Access Compliance Report

Public Rights-of-Way

(Curb Ramps)

Intersection ID: N/A	Main Street: NORTHLAKE_CENTER_PKWY	Cross Street: N/A	Location: SW
ADA ID: 3F64F71130CE	Ramp Type: PerpDiag	Initial Pass/Fail: Fail	Overall Compliance: No
			Severity Score: 13.75

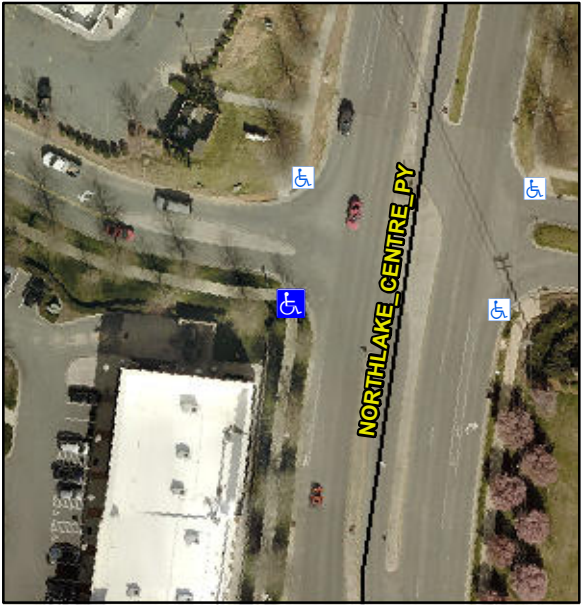
Codes/Mitigation Info/Possible Solution			Field Measurements/Component Compliance		
	Possible Solutions:		Compliance	Description	Data
	Remove & Replace Curb Ramp With Two New Directional Ramps or Equivalent.		No	Ramp Length (in)	47.0
			Yes	Ramp Width (in)	58.0
			N/A	Flare Type LT	N/A
			N/A	Flare Slope LT (%)	N/A
			N/A	Flare Traversable LT?	No
			N/A	Landing Length (in)	N/A
			N/A	Landing Width (in)	N/A
			N/A	Landing Slope (%)	N/A
			N/A	Landing X Slope (%)	N/A
			N/A	Landing Curb? (Y/N)	N/A
			N/A	Shared Landing?	N/A
			N/A	Gutter Ponding?	N/A
			N/A	Gutter Lip Ht (in)	N/A
			N/A	Painted X Walk1?	No
			N/A	X Walk 1 Direction	To E
			N/A	X Walk 1 Width (in)	N/A
			N/A	X Walk 1 Slope (%)	1.4
			N/A	X Walk 1 X Slope (%)	0.9
			N/A	Ramp inside XWalk1?	N/A
<p>Surveyor Notes:</p> <p>N/A</p> <p>PROW/ADA:</p> <p>Not Found, R304.2.2, R304.5.3</p>			N/A	Flare Type RT	N/A
			N/A	Flare Slope RT (%)	N/A
			N/A	Flare Traversable RT?	No
